ADDENDUM NO. 2

DATE: November 7, 2013

Contract 12-C-00042; Howard F. Curren AWTP Raw Sewage Pump Station Improvements

W.O. 4506
SHEET
13

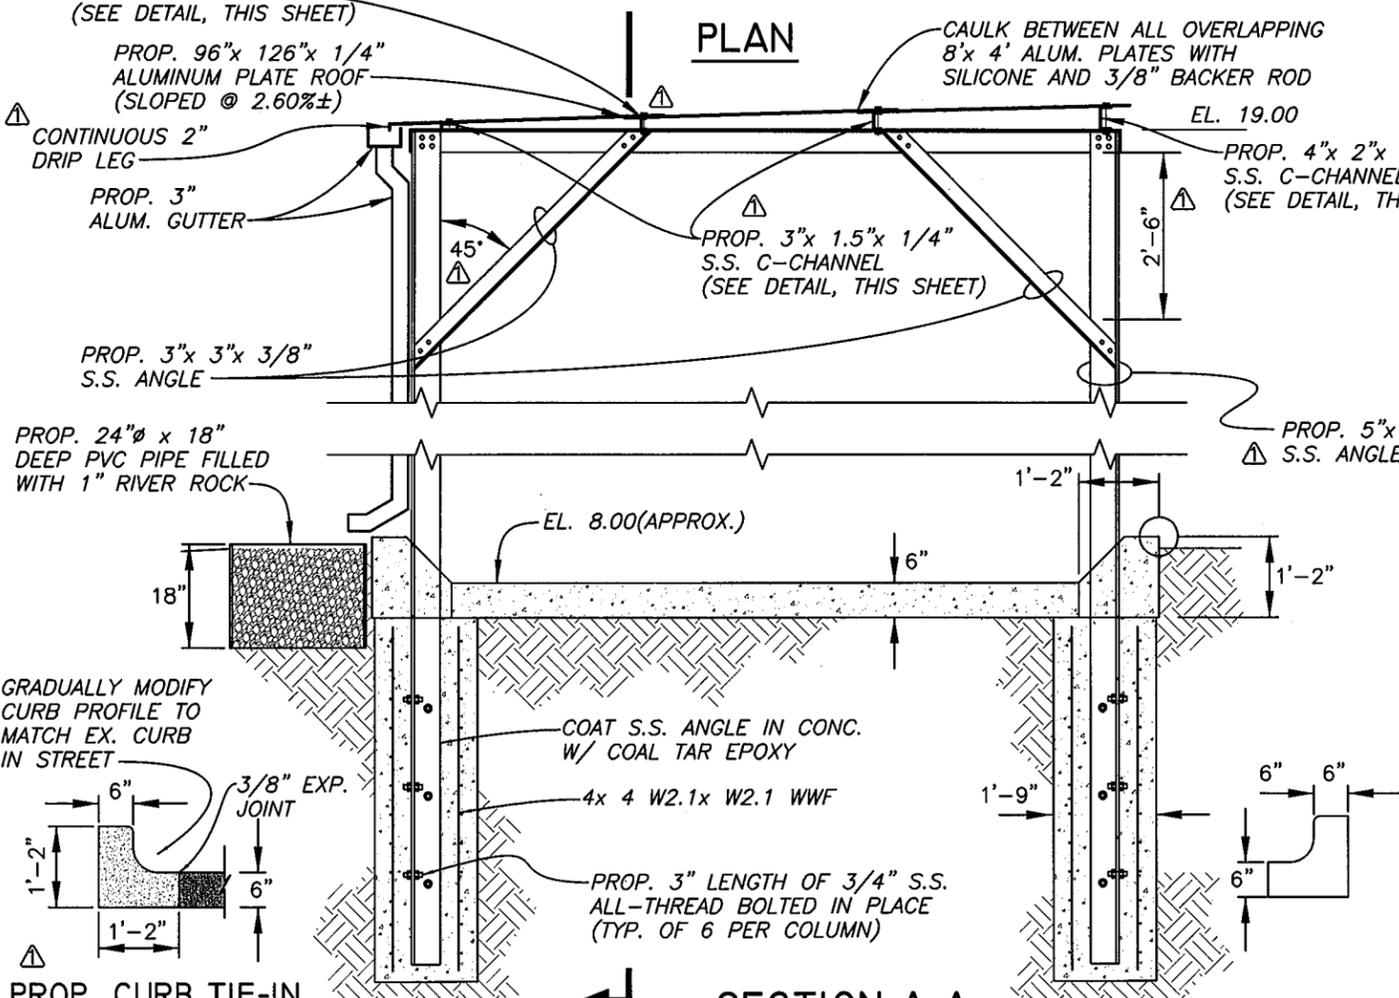
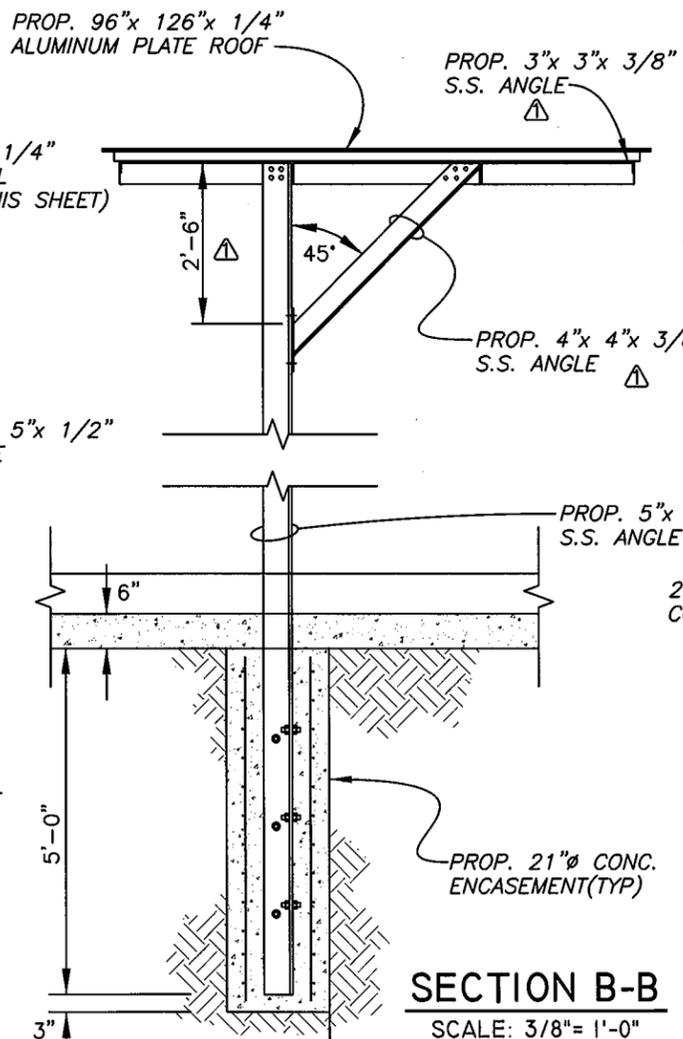
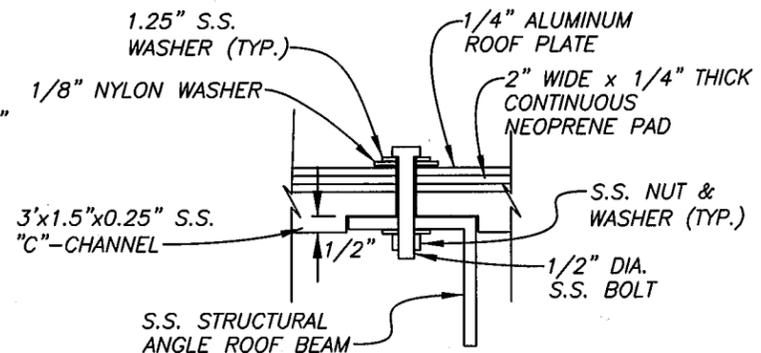
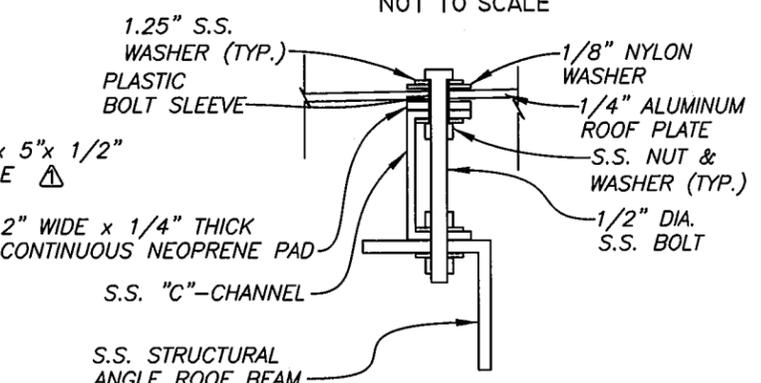
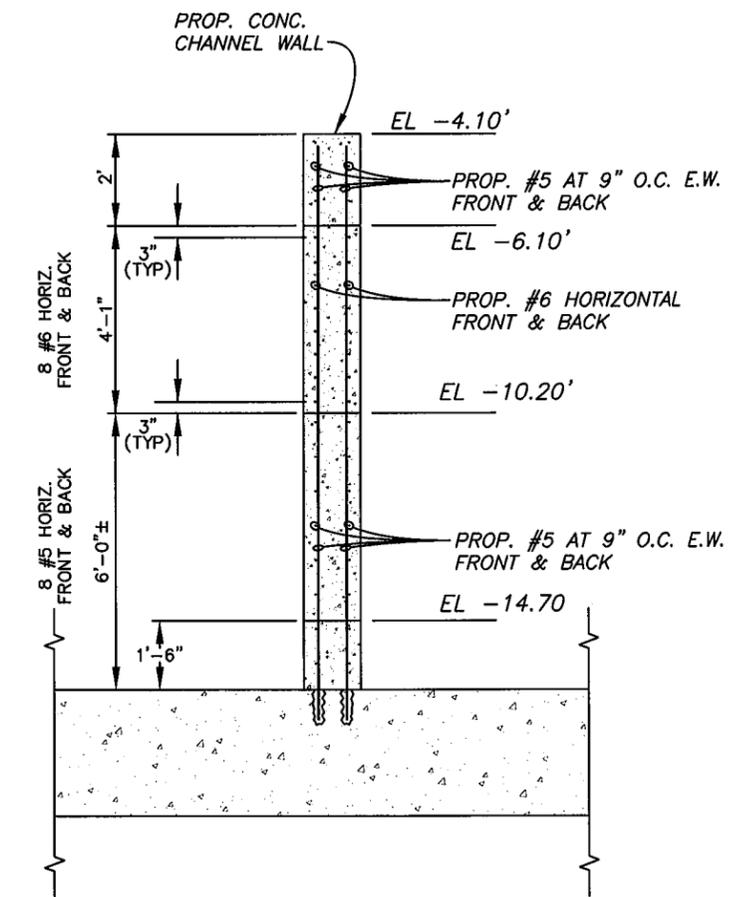
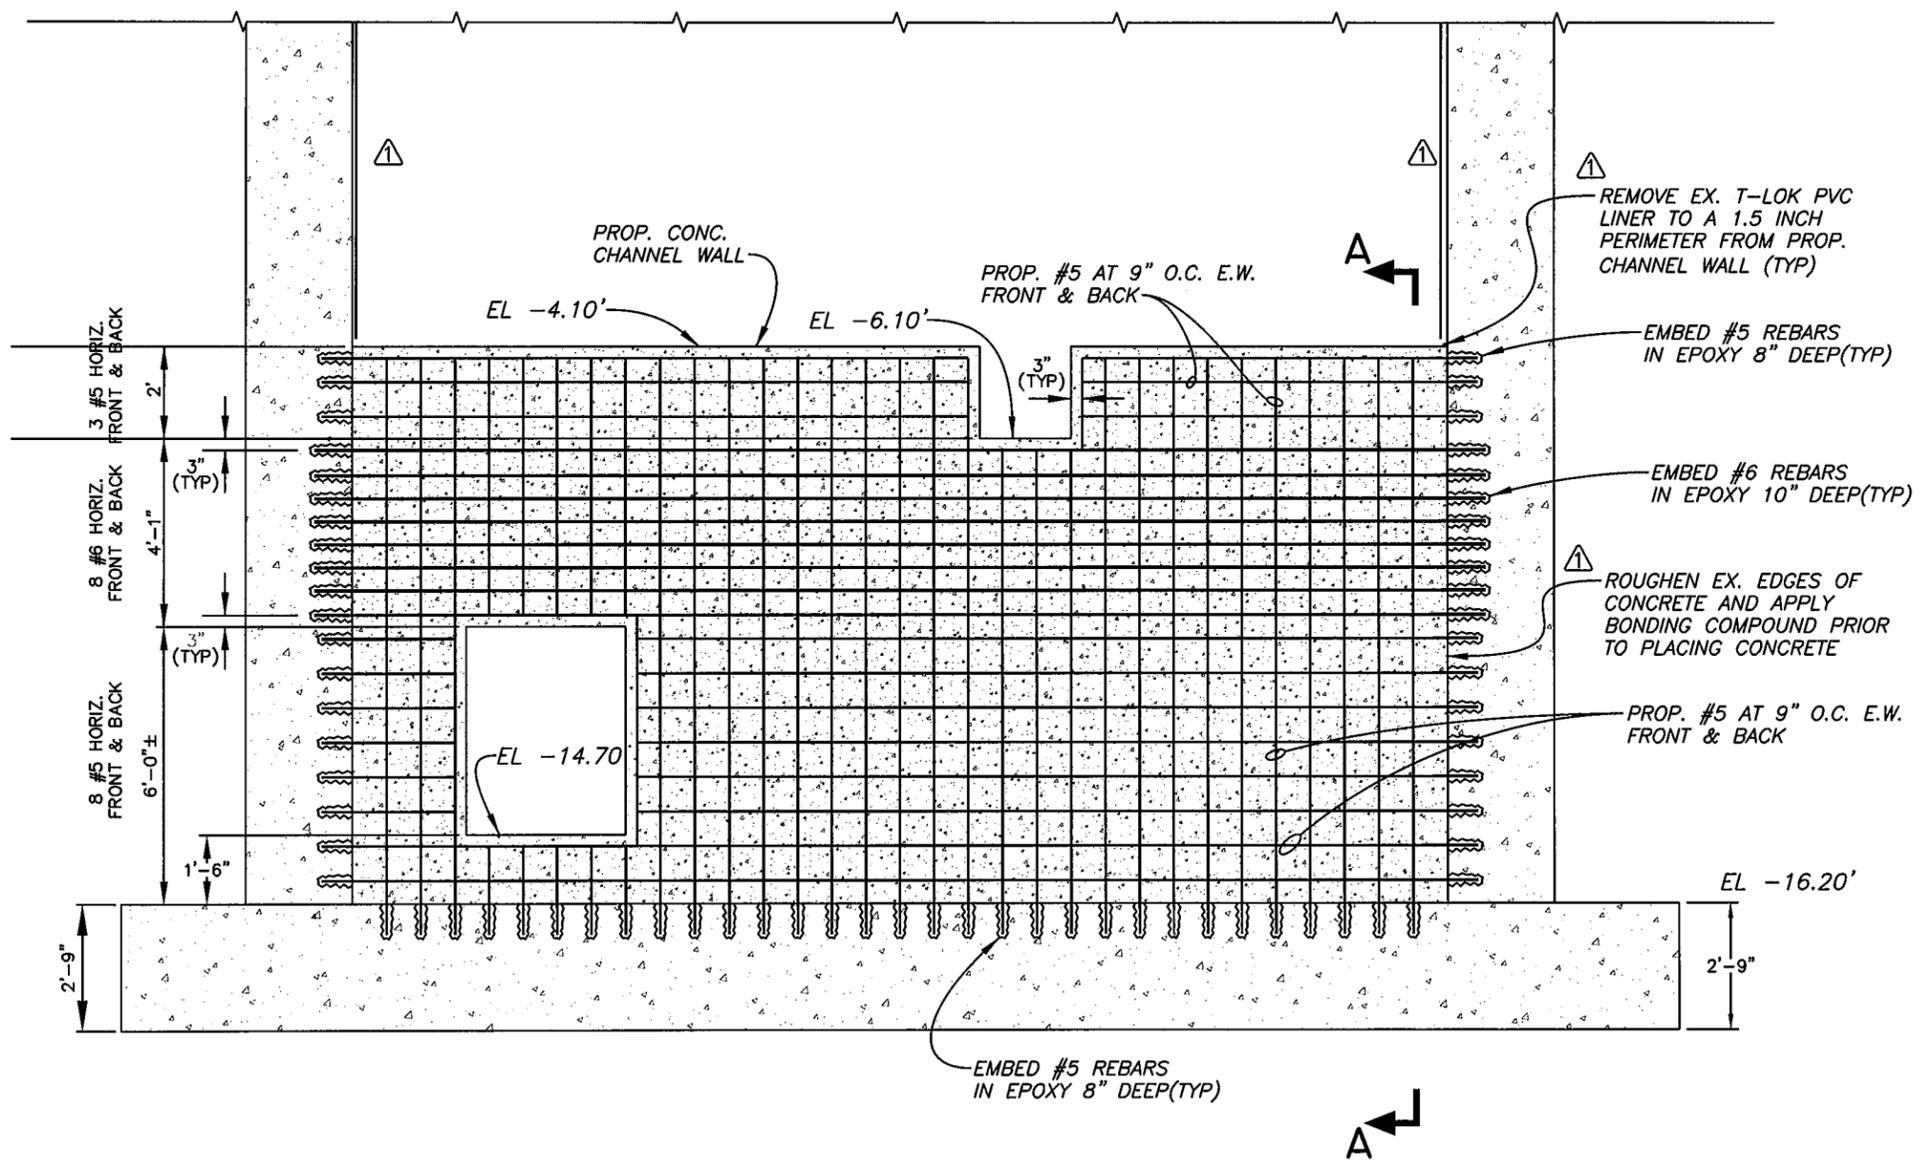
No.	DATE	REVISIONS
3		
2		
1	11/05/13	VARIOUS REVISIONS; ANGLE SIZE, REINFORCING, ROOF & DETAILS

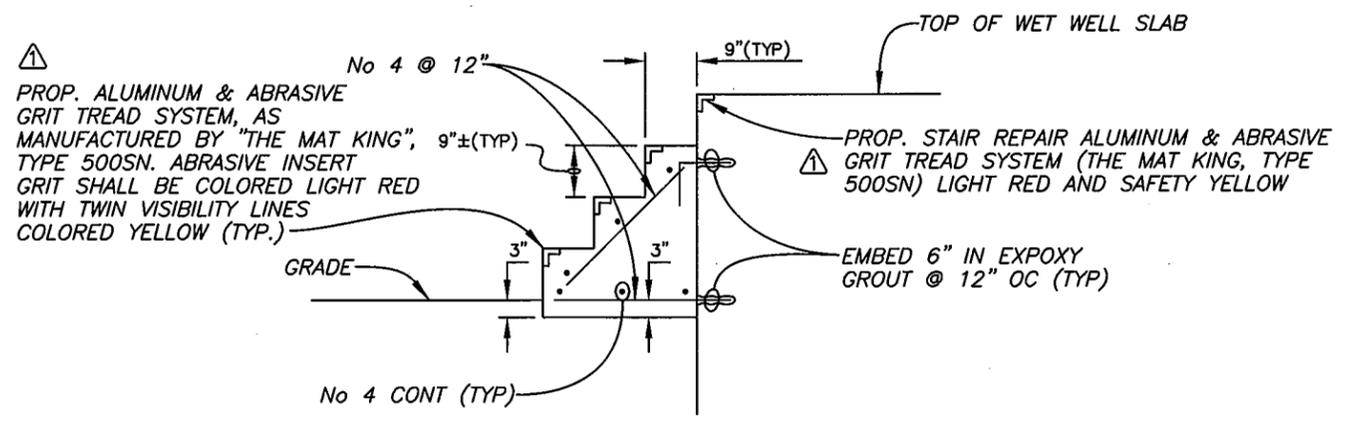
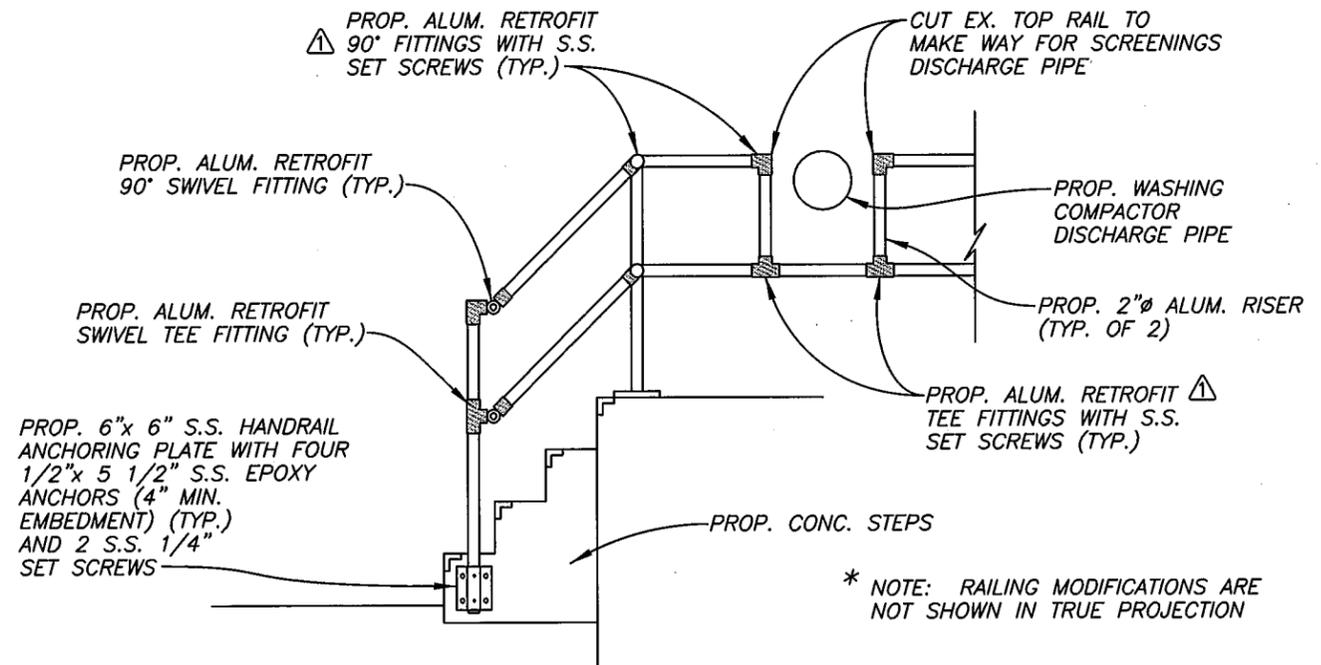
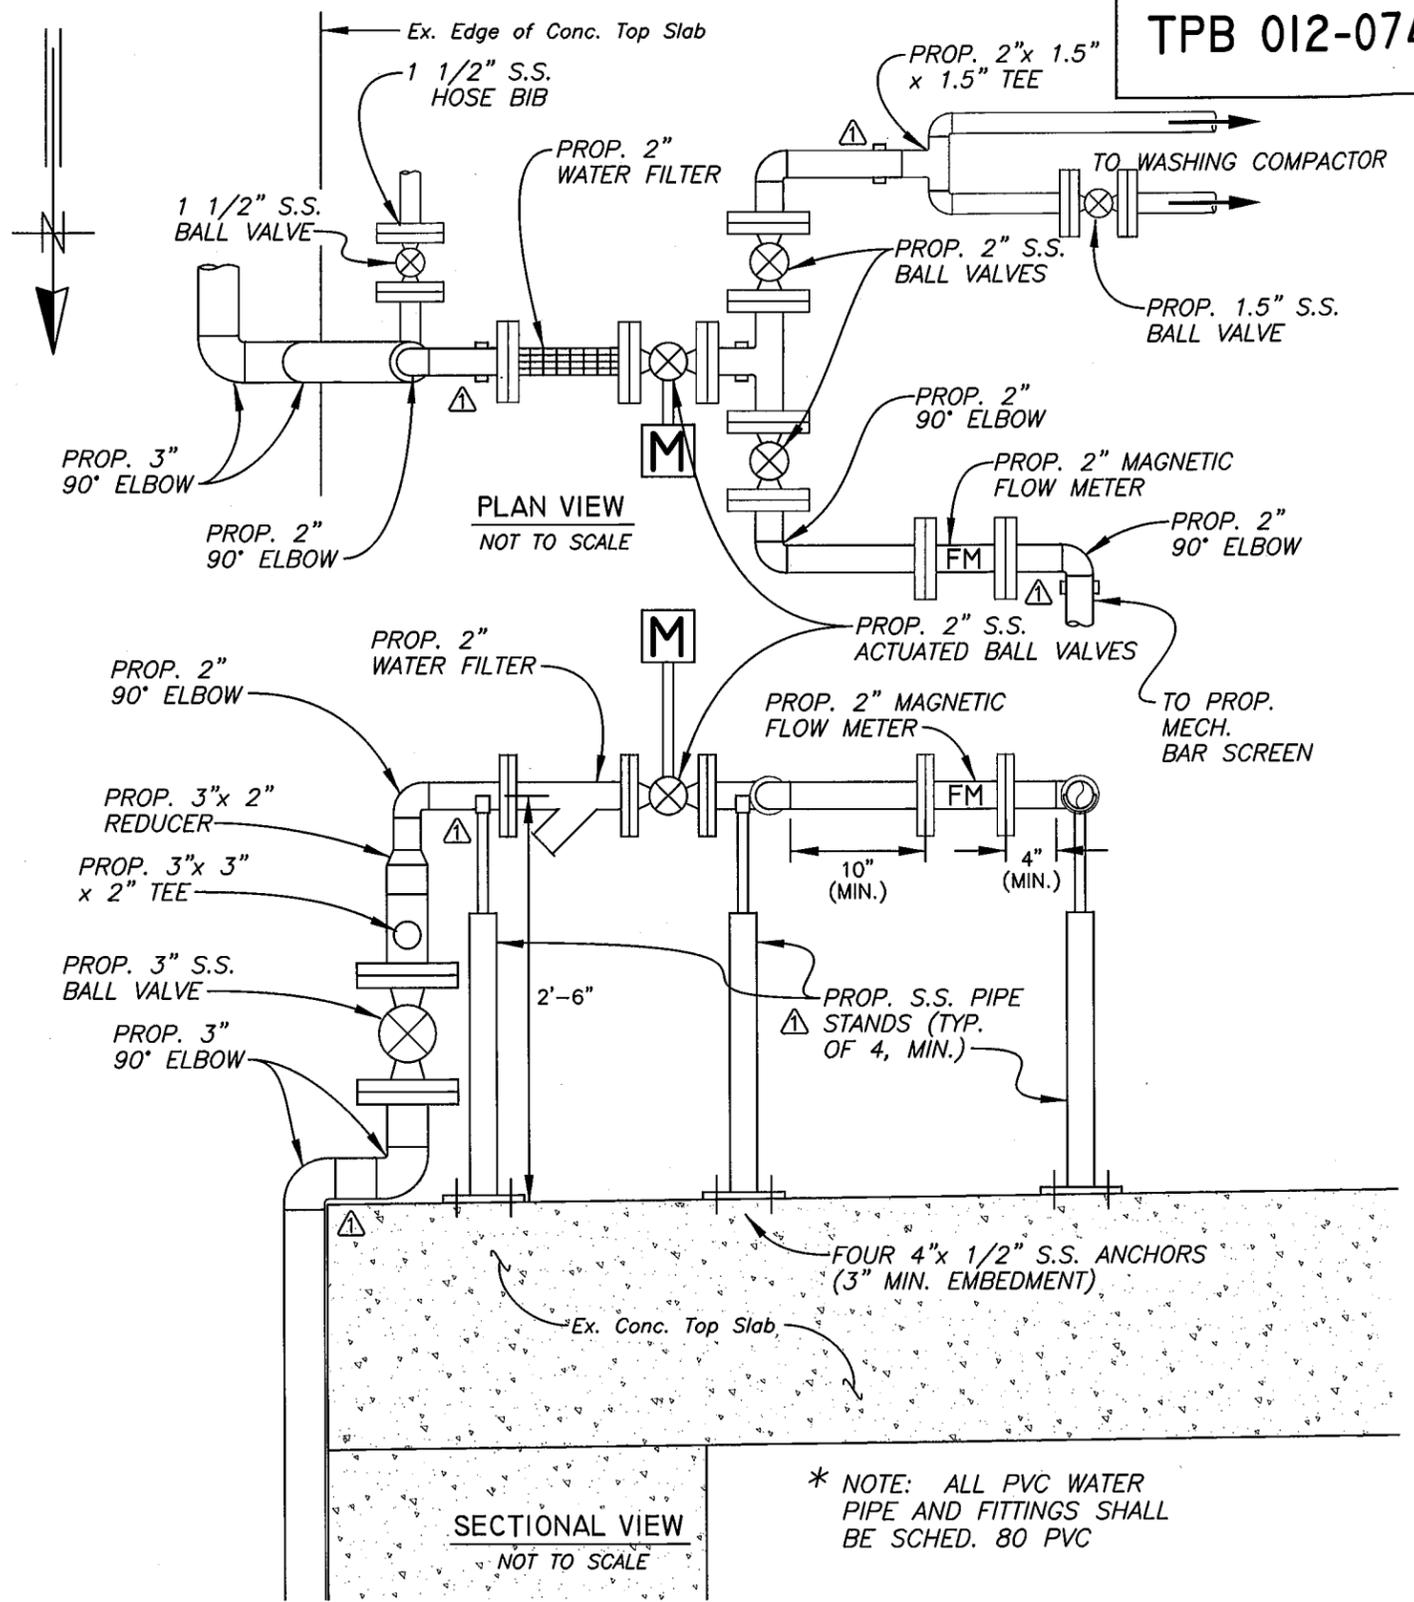
JACINTO CARLOS FERRAS, P.E. #49454 DESIGN DIVISION HEAD WASTEWATER DEPARTMENT	No.	DATE	REVISIONS	DES: J.H.	CITY of TAMPA HOWARD F. CURREN ADVANCED WASTEWATER TREATMENT PLANT	HOWARD F. CURREN ADVANCED WASTEWATER TREATMENT PLANT RAW SEWAGE PUMPING STATION MISCELLANEOUS DETAILS	W.O. 4506
	3			DRN: BB			SHEET
	2			CKD:			15
	11/04/13		VAR. REVISIONS TO NOTES & LINEWORK, ADDED PIPE SUPPORTS	DATE:
